Technical Bulletin

Section Title: Driveline/Axle
 TSB No. TS 06 05227

SUBJECT: FRONT DIFFERENTIAL OIL SEAL REPLACEMENT
MODEL(S): VITARA (SQ420 & SQ625L), GRAND VITARA (SQ625W), GRAND VITARA XL-7 2001~2003 ONLY(JA627)

Drive Shaft Support Installation

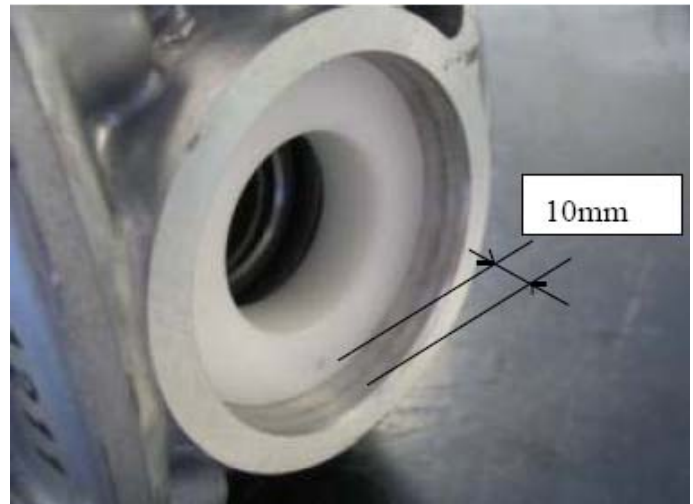
CONDITION: There is now a countermeasure part available to address premature seal failure on the front differential at the right axle.

CAUSE: Axle shaft movement.

CORRECTION: When replacing the right side front differential oil seal be sure to install the new additional support ring behind the oil seal. See below for parts information and instructions.

1. Completely degrease the inside of the sealing surface.

2. Apply oil resistant RTV sealant to the outer surface of the drive shaft support.

3. Insert the support into the differential with the oil hole at the bottom.

4. There should be a depth of ten millimeters between the support and the edge of the differential.

5. Install the oil seal as described in the service manual.
